APPLICATION NO.	FILING DATE	FIRST NAMED INVENTOR	ATTORNEY DOCKET NO.	CONFIRMATION NO.
10/669,745	09/24/2003	Robert J. Boisselle	1-15957	4502
1678 7590 04/03/2007 MARSHALL & MELHORN FOUR SEAGATE, EIGHT FLOOR TOLEDO, OH 43604			EXAMINER LAZORCIK, JASON L	
			ART UNIT 1731	PAPER NUMBER
			MAIL DATE 04/03/2007	DELIVERY MODE PAPER

**Advisory Action
Before the Filing of an Appeal Brief**

**Fig. 2**

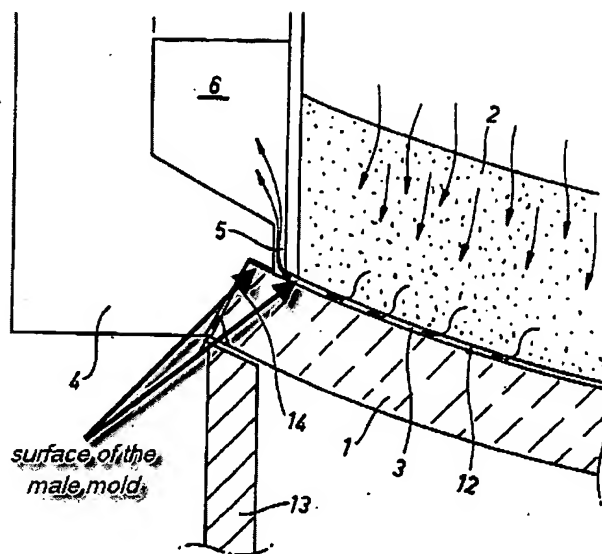
Second, Applicant sets forth arguments on pages 12 and 13 of the instant communication against the rejection of claims 2,3,4,9,15,16, 19 and 21 as rejected under 35 U.S.C. 103(a) over Montonen in view of Posney. Specifically Applicant asserts that the Montonen suction port (5) fails to satisfy "the claimed limitation of at least one peripheral annular groove formed on/in the surface of the male mold". Examiner disagrees.

As clearly depicted in the Montonen reference figure 2 excerpt above, at least mold elements (4) and (2) present a molding surface to the glass sheet (1) as indicated by the annotation lines. Therefore elements (4) and (2) would be conventionally recognized collectively as a pressing face or alternatively as a "surface of the male mold". With this point in mind, it is clear that the peripheral annular groove (5) is formed "in/on the surface of the male mold".
